STAFF RECOMMENDATION 3629 Richland Avenue Lot 7, Richland Hall Development June 20, 2018

Application: New construction—infill and outbuilding; setback determination
District: Richland-West End Neighborhood Conservation Zoning Overlay
Council District: 24
Map and Parcel Number: 10409029600
Applicant: Chad Gore, Mike Ford Builders
Project Lead: Jenny Warren, jenny.warren@nashville.gov

Description of Project: Application is to construct a new single family infill and an outbuilding. The project requires a change to the left side setback. Base zoning requires a five foot (5') side setback and the applicant is proposing a three foot (3') side setback.

C2
 SITE PLAN

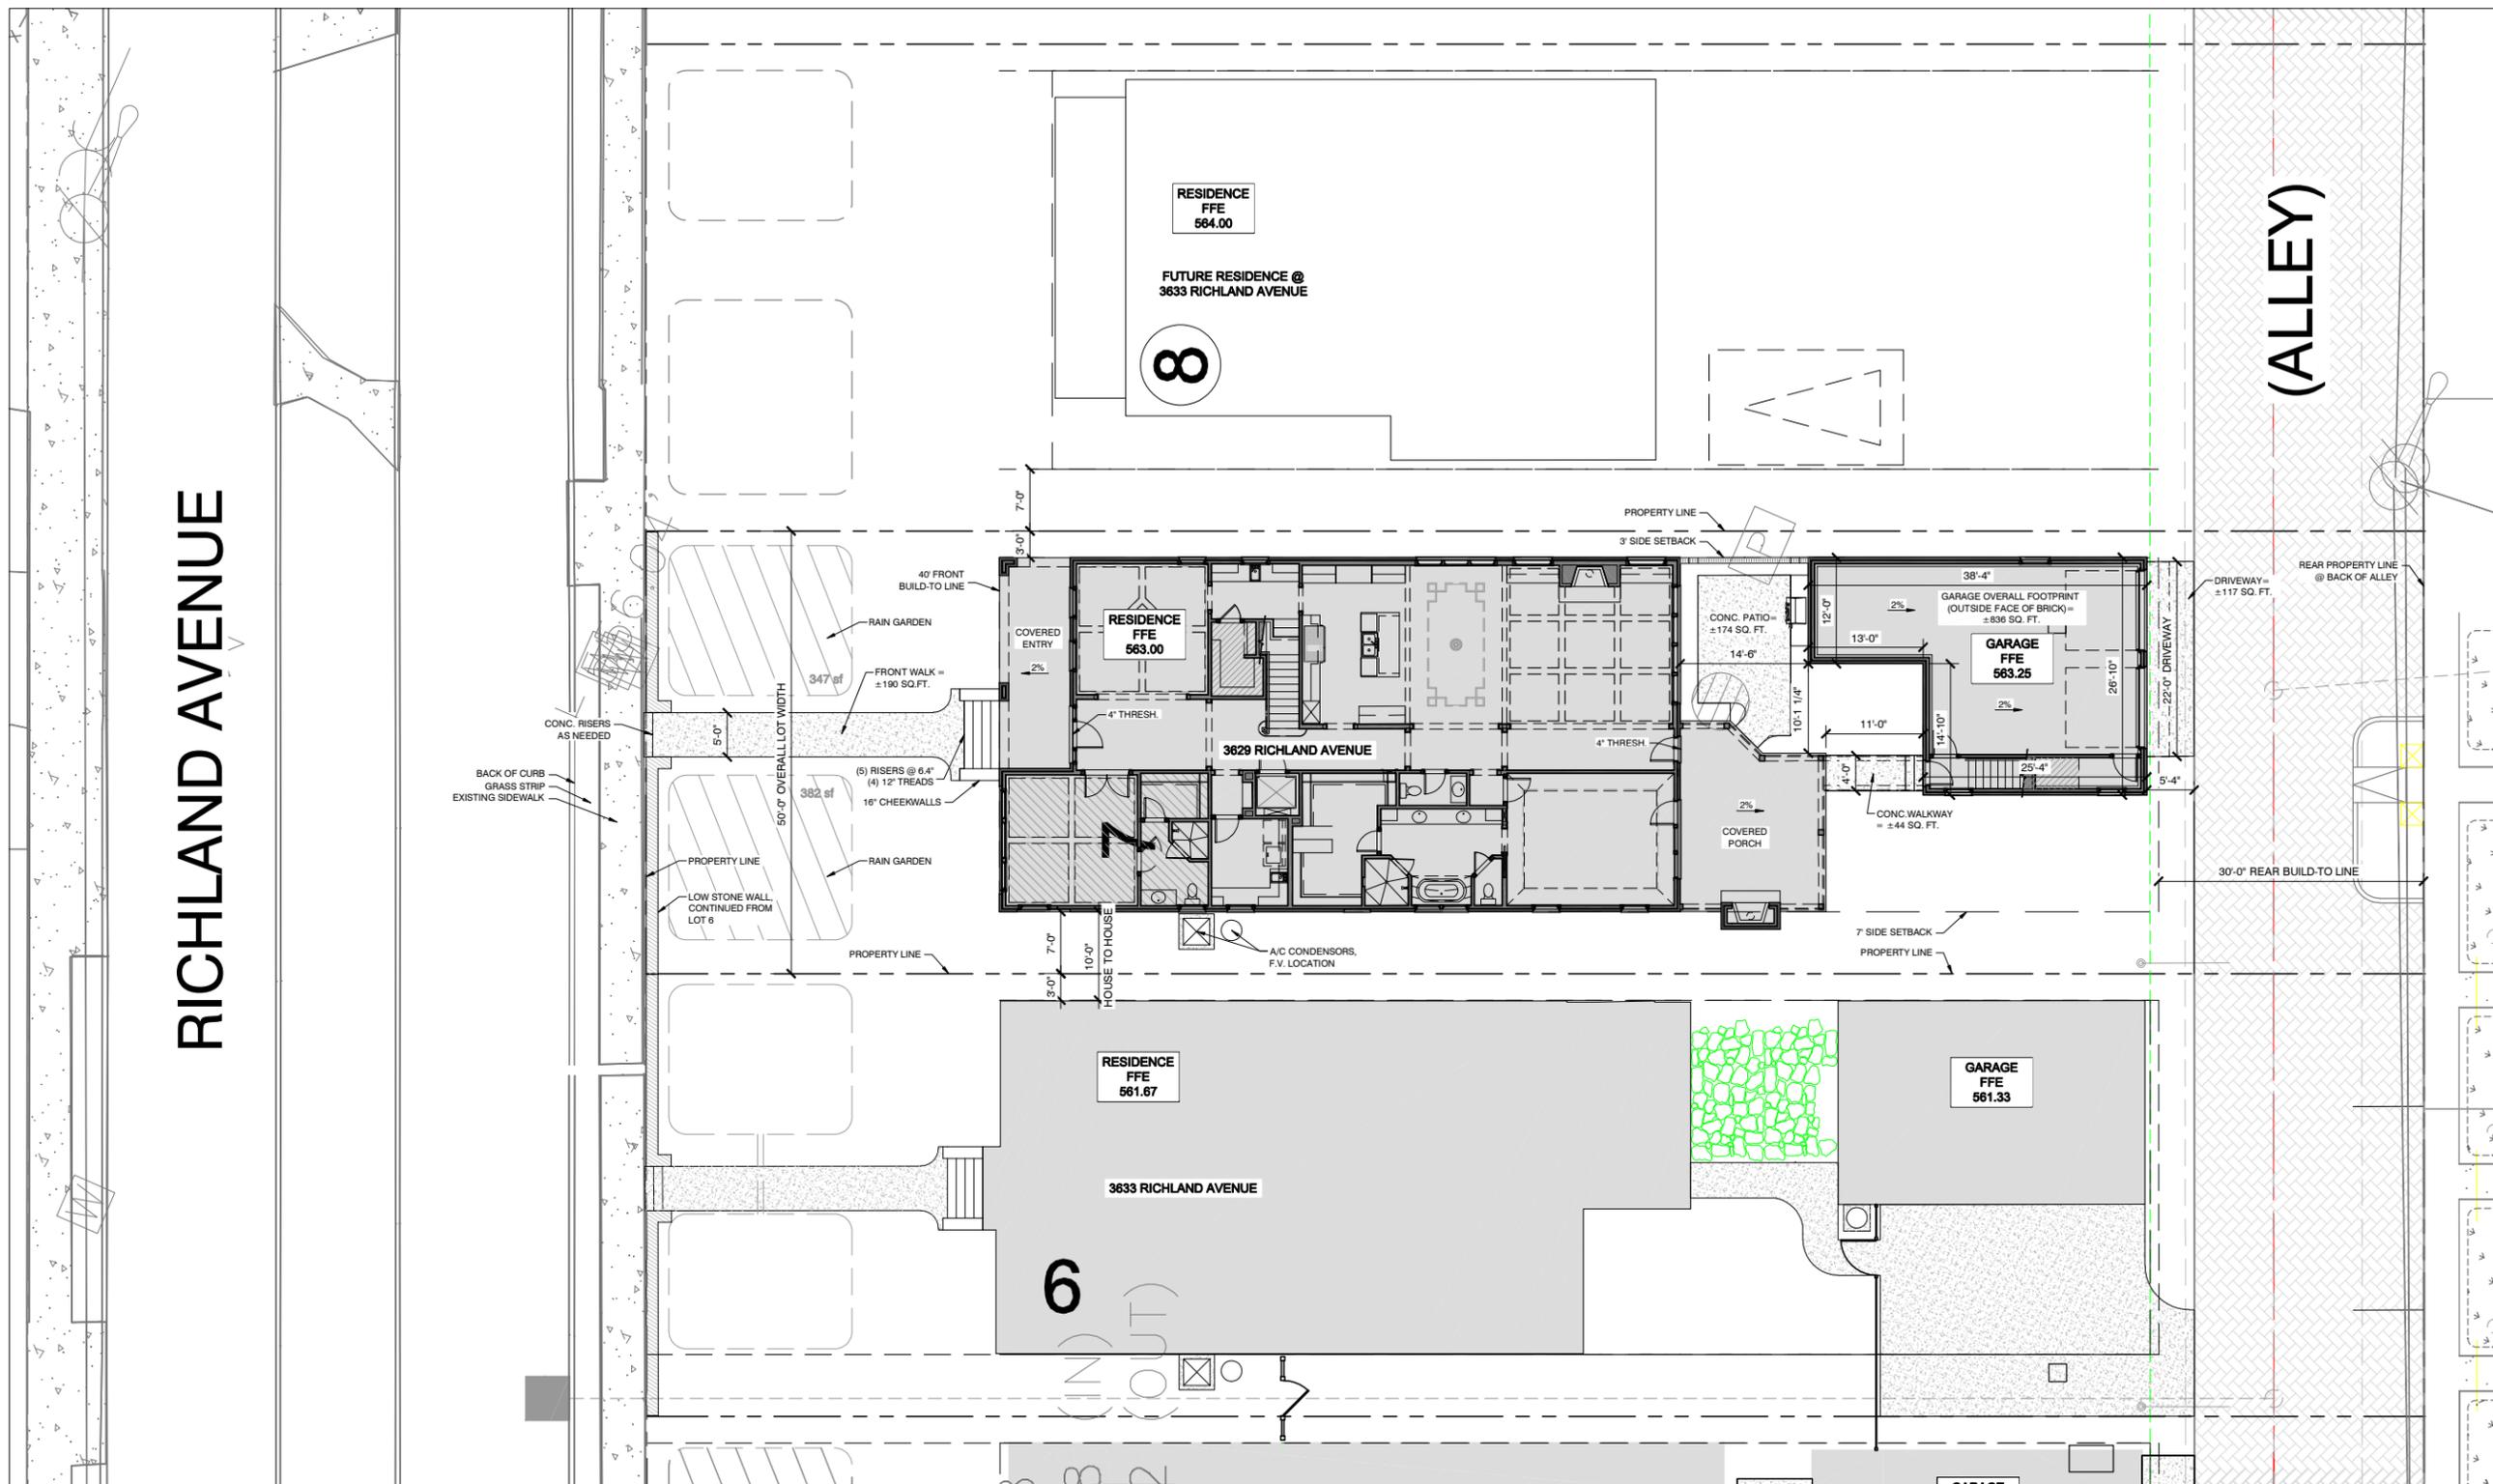
Setback & Rhythm of Spacing: The proposed infill will have a front setback of forty feet (40'), which will line up with the infill houses already approved by the Commission for this development, including Lot 6 immediately to its right.

The right side elevation will be seven feet (7') from the side property line, which meets the base zoning setback of five feet (5'). On the left side, base zoning requires a five foot (5') side setback, but the applicant is proposing to set the infill just three feet (3') from the side property line. Staff finds this reduced side setback to be appropriate because there are other homes in the immediate vicinity that do not meet the required five foot (5') side setback. In addition, the infill is part of a larger development, and the reduced setback will affect the parcel next door at 3625 Richland Avenue, which is also part of the larger development. Staff has yet to review the site plan for 3625 Richland Avenue, but has directed the applicant that the right side of No. 3625 needs to be set seven feet (7') from the side property line. This will ensure there is at least ten feet (10') in between nos. 3629 and 3625 Richland Avenue and that the reduced side setback will not affect overall rhythm of spacing on the street. For Lots 1, 2, 3, 4, 5 and 6 of this development, the Commission has approved similar setback determinations.

Staff finds that the proposed setbacks to be similar to the immediate historic context and to meet Section II.B.1.c. of the design guidelines.

*The Commission typically requests to see at least twenty feet (20') between the primary structure and the outbuilding. The applicant is proposing just eleven feet (11') in between the structures. The Commission has approved a shorter distance of ten feet (10') in between the primary structures and the outbuildings for Lots 1, 2, 3, 4 and 5 of this development. Staff recommends approval of the distance between the infill and the outbuilding for Lot 7. The overall development is creating a new alley at the rear of the lots, which will make the back portion of the lot unavailable for building. Approximately the back thirty feet (30') of the lot is used for the alley. The outbuilding cannot be pushed any further to the rear because of the new alley. Therefore, staff finds that the distance in between the primary house and the outbuilding to be sufficient.

** The Commission has established that outbuildings can be as little as five feet (5') from the rear property line. The proposed outbuilding will be over thirty feet (30') from the rear property line, thereby meeting the design guidelines. Base zoning requires a five foot (5') side setback for outbuildings with footprints over seven hundred square feet (700 sq. ft.). The outbuilding will meet the right side setback, but will require a side setback determination on the left side property line. It will be just three feet (3') from the left side property line rather than the required five feet (5'). Staff finds the proposed three foot (3') side setback to be appropriate because it will line up with the setback of the proposed infill. In addition, historically, outbuildings were located close to or on the side property lines. MHZC approved three foot (3') left side setbacks for Lots 1, 2, 3, 4, 5, and 6 of this development.

1 ROOF PLAN
1/8" = 1'-0"

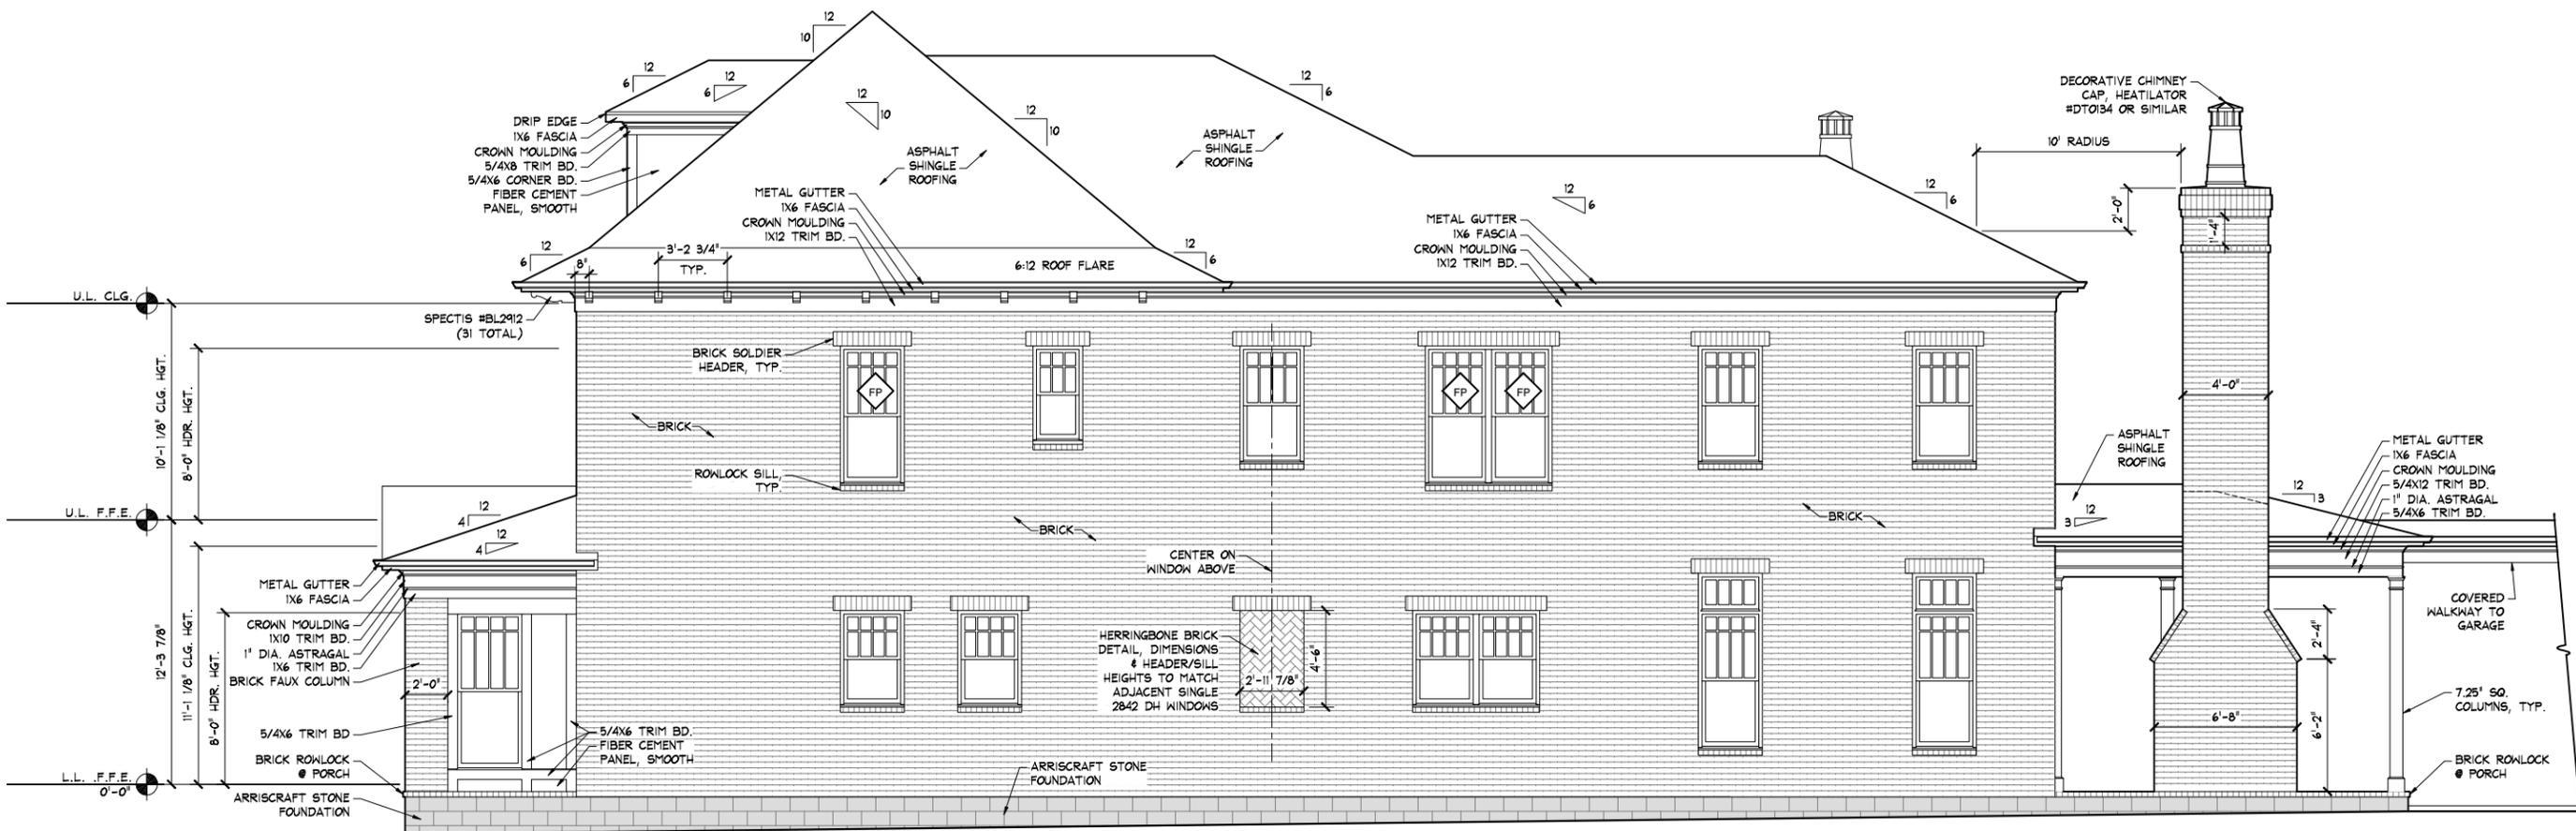
Roof form: The infill’s primary roof form is hipped on the front and side elevations with a 10/12 slope. Beyond the primary hip is a secondary hipped roof with a 6/12 slope. The front porch roof will have a 4/12 slope.

Staff finds that the proposed roof forms are appropriate for a two-story infill house in the overlay, and finds that the roof forms meet Section II.B.1.e. of the design guidelines.

1 FRONT ELEVATION
1/8" = 1'-0"

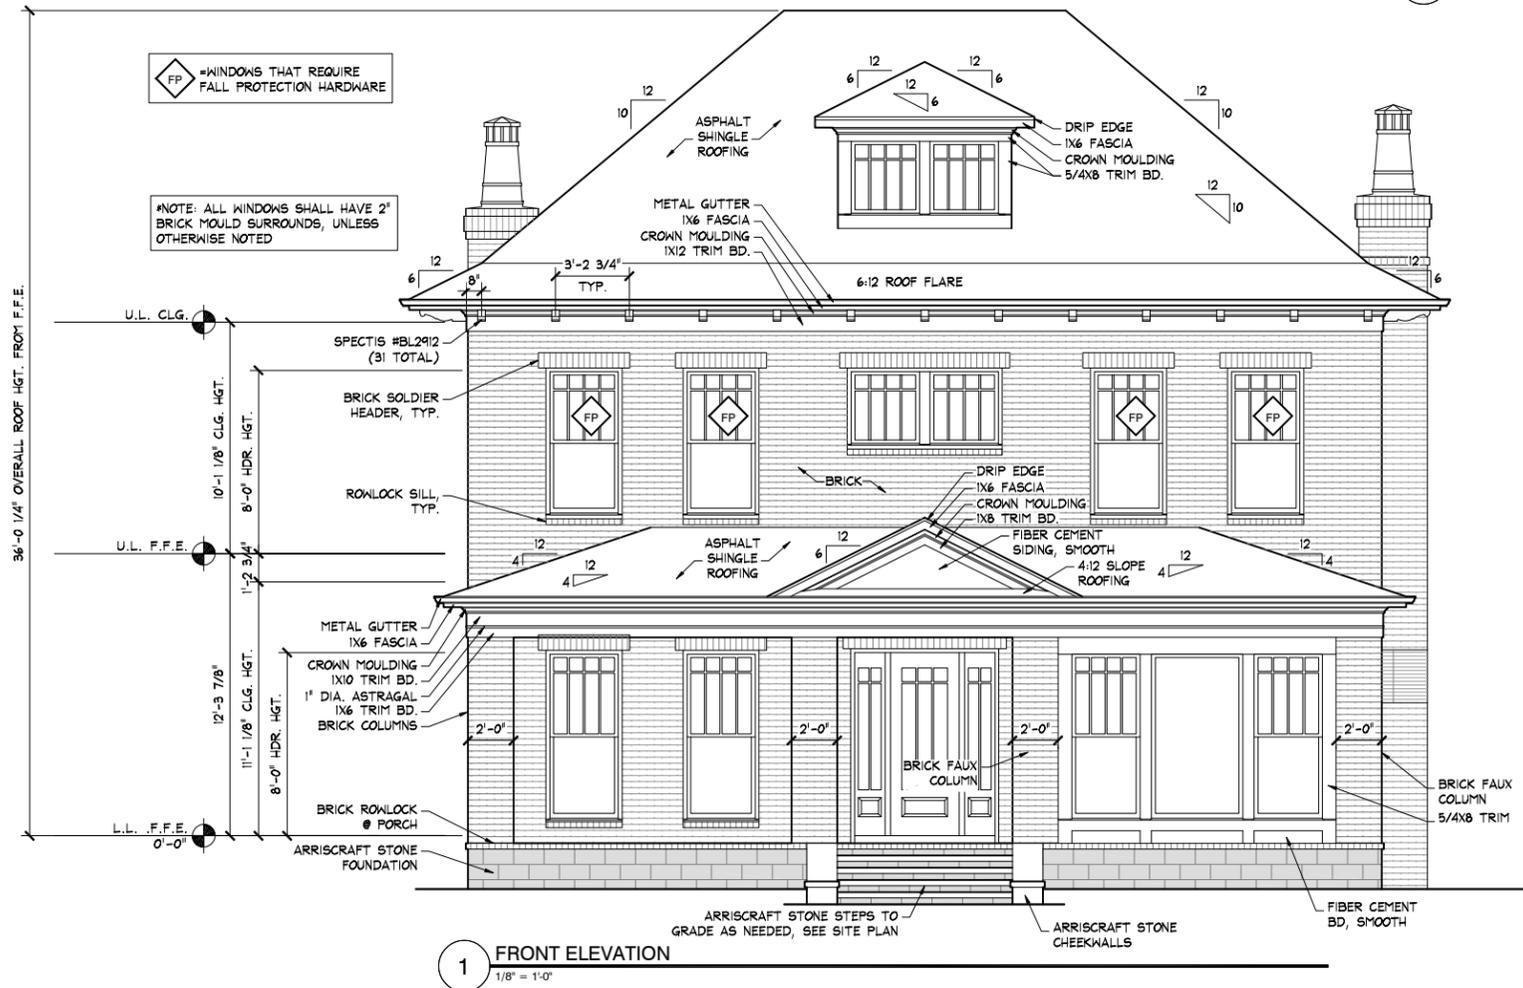
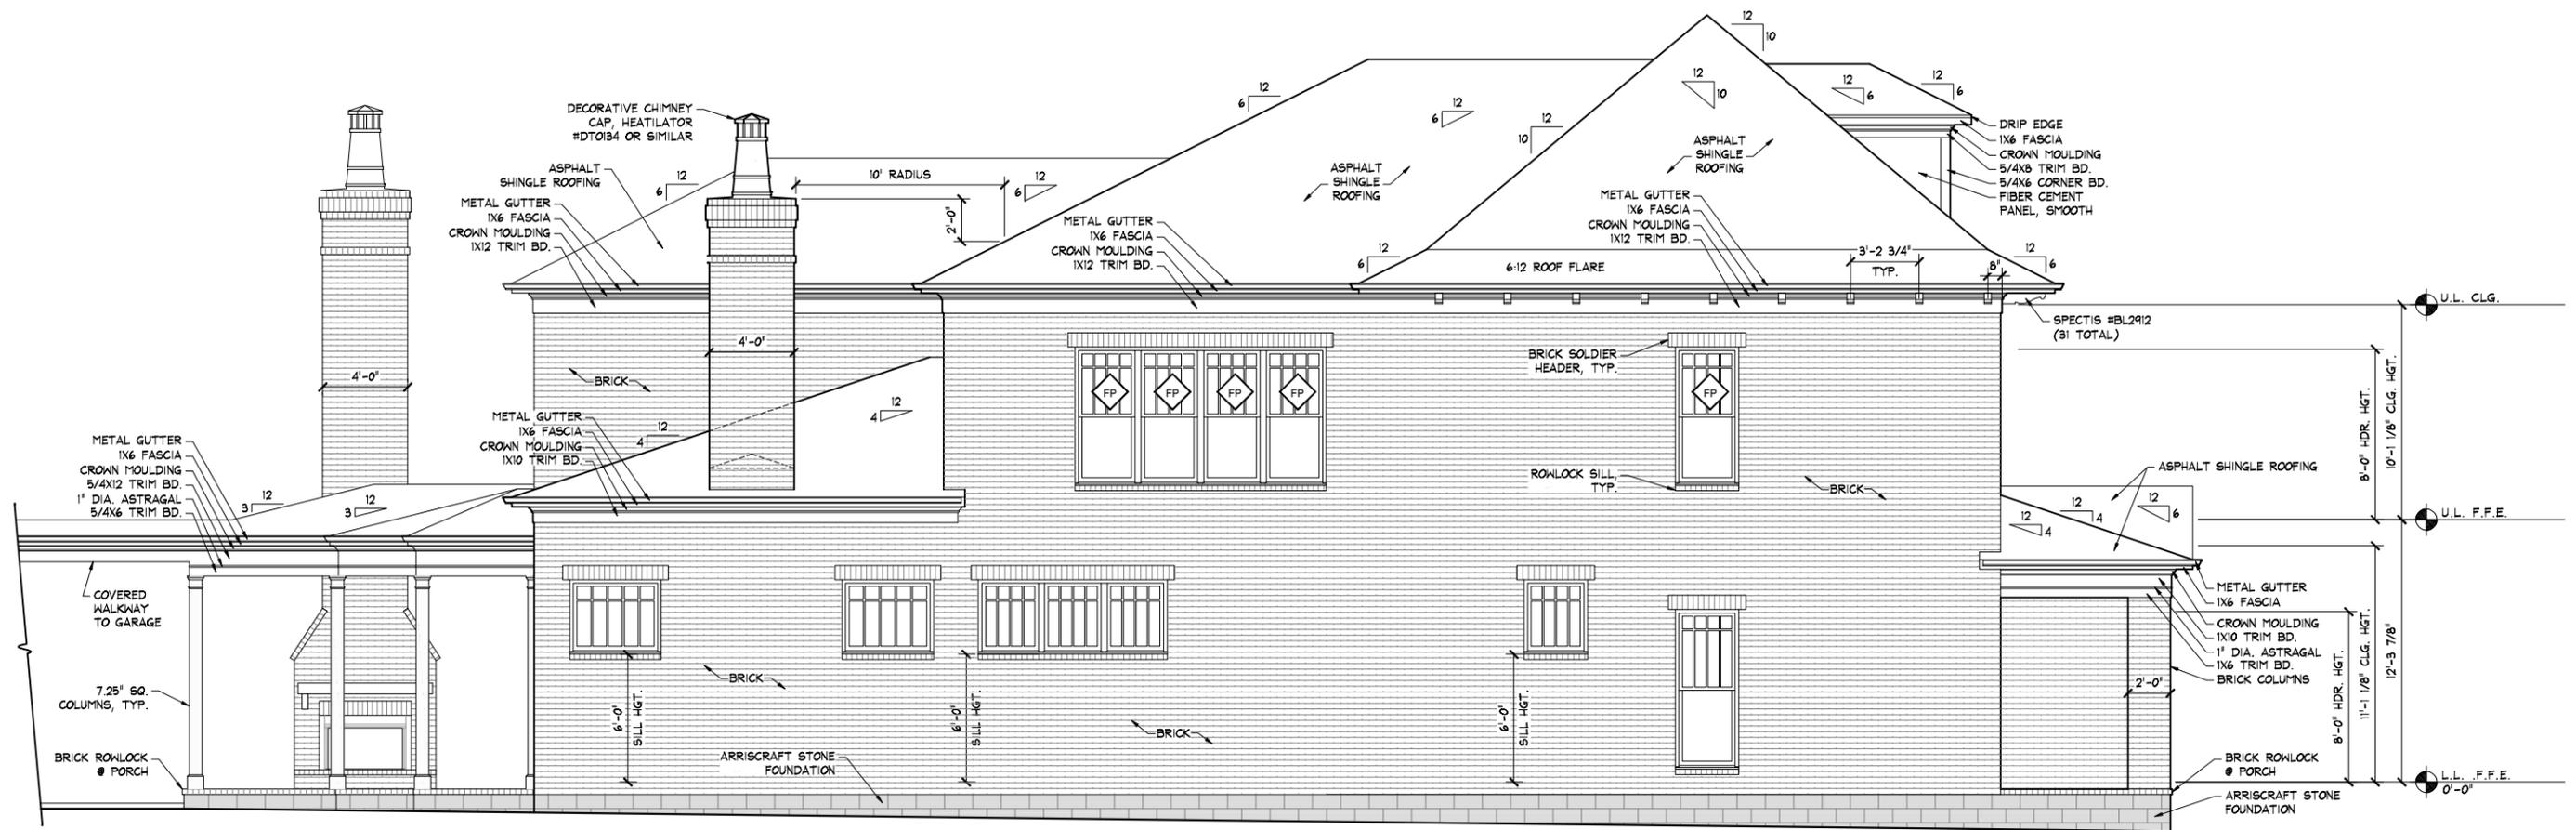
Height & Scale: The proposed infill will be two stories, with a maximum height of thirty-six feet (36') above the foundation at the front, and approximately thirty-eight feet (38') above grade. The infill will have an eave height of approximately twenty-two feet (22') above the foundation at the front. The foundation height will vary due to grade, but will be approximately twenty-four inches (24") at the front. Staff finds that the proposed height is similar to the heights of historic houses in the immediate vicinity, which range from thirty to forty-four feet (30' – 44'). It is also in keeping with what has been approved in the past for the infill houses in this development, notably, the property next door at 3633 Richland Avenue, which was approved in 2017 with a height of thirty-eight feet, six inches (38'6") above the foundation.

Staff recommends verification of the construction height of the foundation and floor systems in the field to ensure that the finished floor line of the new construction is compatible with the historic context. With this condition, staff finds that the height and scale meet Sections II.B.1.a. and II.B.1.b. of the design guidelines.

Proportion and Rhythm of Openings: The proposed windows on the infill are generally twice as tall as they are wide, thereby meeting the historic proportion of window openings. There are no large expanses of wall space without a window or door opening. On the right side elevation the applicant has added a blind window to break up a long expanse of wall – the Commission has approved this treatment in other houses on the former Welch College campus. All window groupings have a four to six inch (4”-6”) mullion in between the individual window openings. On the front elevation, there is a pair of nearly square windows in the center bay, below similar windows in the dormer. Staff finds these to be appropriate, because they are an accent, not the dominant window form, and because windows of this type are seen on historic examples. Similar windows are found on the left elevation, Staff finds these to be appropriate, because the majority of them are over forty-five feet (45’) back from the front of the house and because they are used sparingly. Staff finds that the infill’s proportion and rhythm of openings meet Section II.B.1.g. of the design guidelines.
